SUNDRY NOTICES AND REPORTS ON WELLS

7. If Unit or CA/Agreement, Name and/or No
NMNM710168. Well Name and No
POKER LAKE UNIT #2279. API Well No
30-015-3392910. Field and Pool, or Exploratory Area
NASH DRAW - DELAWARE11. County or Parish, State
EDDY
NM

PROPOSED WELLBORE DIAGRAM

Plug Back Conditions of Approval

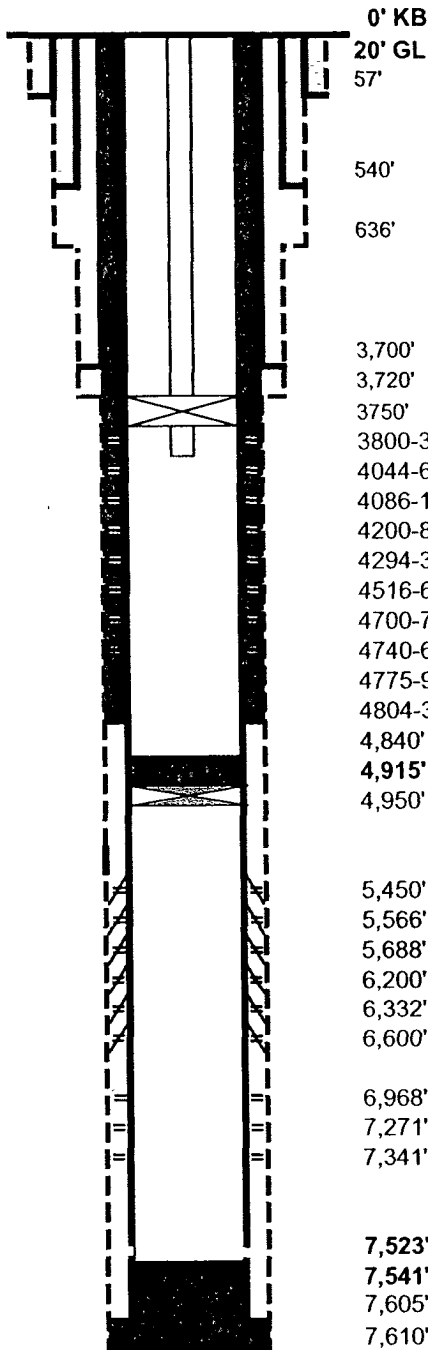
- I. Notify the BLM @ (575) 361-2822 a minimum of 4 hours before commencing operations in order for a representative to witness.
- II. A cement or bridge plug must be set opposite or above the lower perforations (6,968'–7,347') and be in accordance with O.O.2.III.G.2. which reads:

- III. The bridge plug proposed @ 4,950' is to be lowered 50 to 100 feet above the squeezed middle perforations (5,450'-6,640') to comply with O.O.2.III.G.2.

2. Cased Hole. A cement plug shall be placed opposite all open perforation and extend to a minimum of 50 feet below (except as limited by TD or PBTD) to 50 feet above the perforated interval. All cement plugs, except the surface plug, shall have sufficient slurry volume to fill 100 feet of hole, plus an additional 10 percent of slurry for each 1,000 feet of depth. In lieu of the cement plug, a bridge plug is acceptable, provided:

- i. The bridge plug is set within 50 feet to 100 feet above the open perforations;
 - ii. The perforations are isolated from any open hole below; and
 - iii. The bridge plug is capped with 50 feet of cement. If a bailer is used to cap this plug, 35 feet of cement shall be sufficient.
